Conrad Fisher Park

Conrad Fisher Park is a large neighborhood park that provides ballfields, tennis, playgrounds, picnic areas and walkways. The main issues at this park are accessible routes to at least one ballfield, abrupt transitions, slopes too high, and accessible features at the playground. **Please Note:** When a **UD** is indicated, this is a Universal Design (**UD**) recommendation to enhance accessibility. The **UD** recommendation is not required to meet the minimum accessibility standards but it would be encouraged.

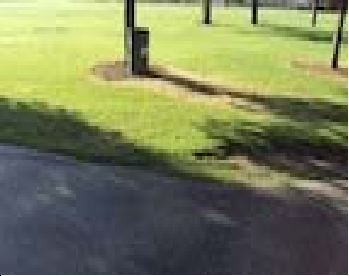
| Photo | Barrier | ADAAG/IAC | Solution | Priority | By Whom | Projected Cost | Projected Date | Action Taken |
|--|---|----------------|---|----------|------------------|----------------|----------------|--|
|  | The walkway behind the bleachers has a dip of 3/4" for 9'. | ADAAG 302.3 | Fill in or replace section of sidewalk to provide a flush transition or an opening no greater than 1/2'. | | All Star Asphalt | \$300 | 2018 Capital | Replaced walkway as part of 2018 paving 6/2018 \$14,000 |

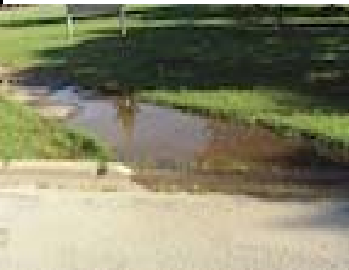
| Photo | Barrier | ADAAG/IAC | Solution | Priority | By Whom | Projected Cost | Projected Date | Action Taken |
|--|---|--|---|----------|---------|----------------|----------------|--|
|  | At the drinking fountain there is an abrupt transition of 1". | ADAAG 303 | Grind down or replace section of sidewalk to provide a smooth transition. | | | \$250 | 2018 | Fountain and pad replaced as part of 2018 Conrad Fisher redevelopment 6/2018 |
